Subject: James A. FitzPatrick Nuclear Power Plant  
Docket No. 50-333  
Additional Information Concerning  
Crescent Area Ventilation Surveillance Tests

ATTACHMENT TO JPN-84-28  
NEW YORK POWER AUTHORITY  
JAMES A. FITZPATRICK NUCLEAR POWER PLANT

FIGURE-1

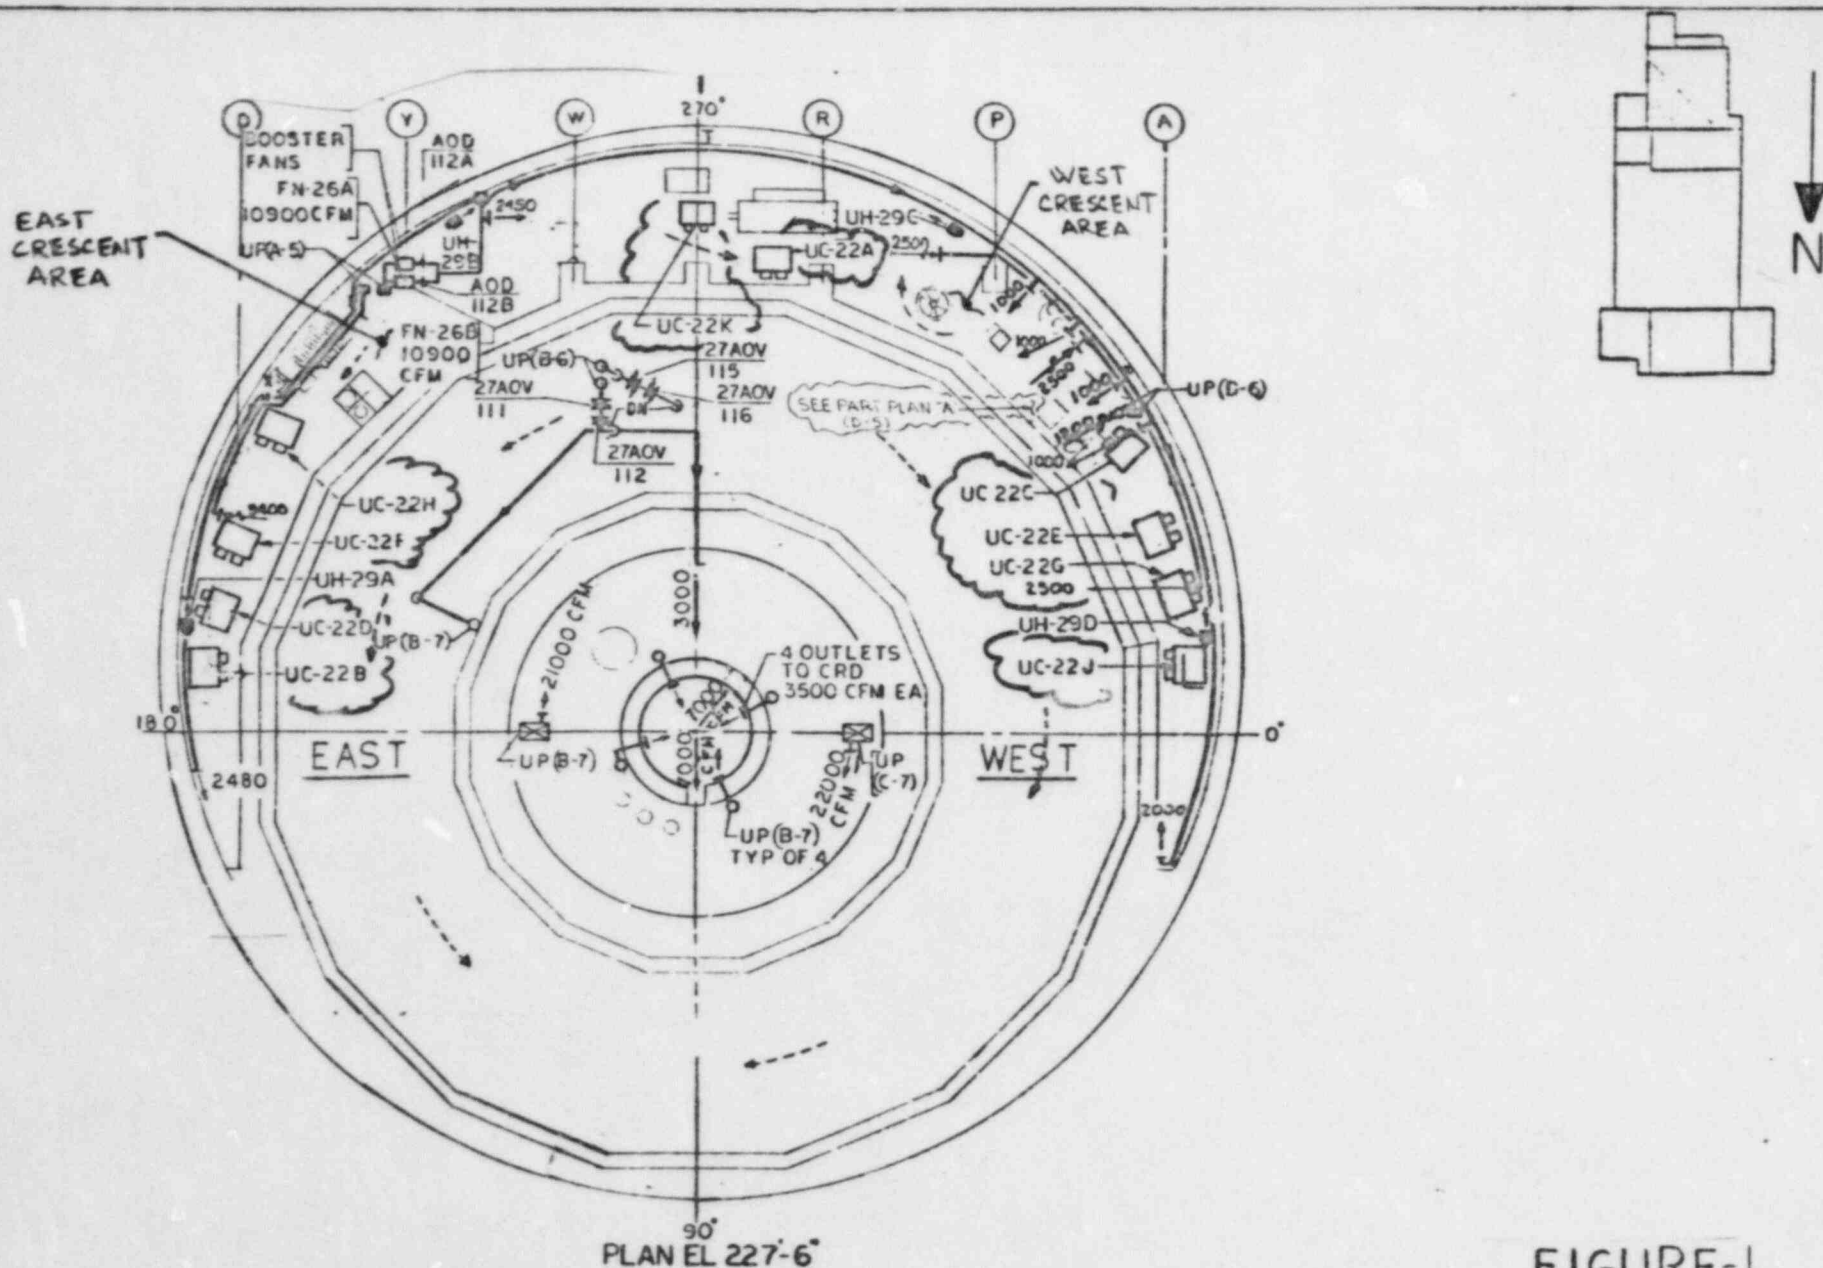
NRC Question 1:

Identify all the unit coolers and Emergency Core Cooling System (ECCS) component & equipment located in the east and west crescent areas.

There are ten (10) unit coolers in the crescent area; five (5) in the east crescent area and five (5) in the west crescent area (see fig. 1). ECCS equipment and components in each of the crescent areas are listed in Table 1 below and shown on Figure 2:
